REVIEW OF ENGINEER'S REPORT  
FOR  
PROPOSED SALIX DRAINAGE DISTRICT  
WOODBURY COUNTY, IOWA

RE: REVIEW OF ENGINEER'S REPORT  
WRITTEN BY VEENSTRA & KIMM, INC.  
PROPOSED SALIX DRAINAGE DISTRICT

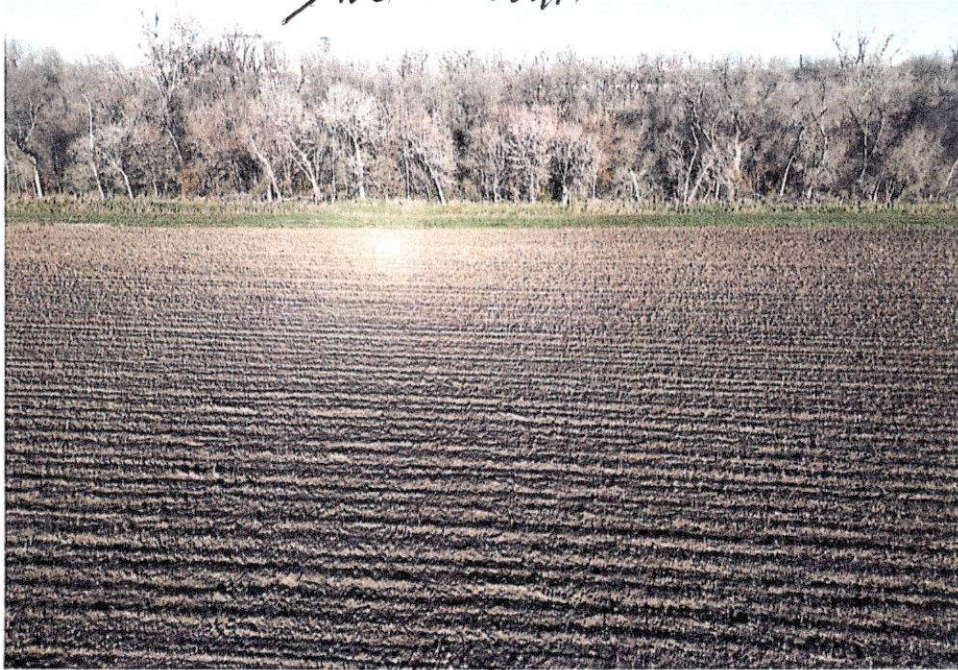
The main ditch length from the Snyder's Bend oxbow to the intersection of Benton Avenue and 280<sup>th</sup> Street is 2.80 miles. Using the alternative ditch route shown on the attached aerial photograph results in a ditch length of 2.25 miles from the Snyder's Bend oxbow to the intersection of Benton Avenue and 280<sup>th</sup> Street. This shorter distance will yield a beneficial steeper slope resulting in higher velocity flows thus keeping the ditch cleaner. Also, the higher velocity flows should reduce the required width of the ditch.

This alternative route will provide for an outlet fully controlled by the proposed drainage district without reliance on the DNR for maintenance. This route also eliminates multiple entrance crossings and their associated culverts, thereby reducing initial costs and future maintenance. Finally, the number of residential parcels from which R-O-W will be acquired is reduced thus saving in R-O-W acquisition costs since residential property typically has a higher value per acre than agricultural property.
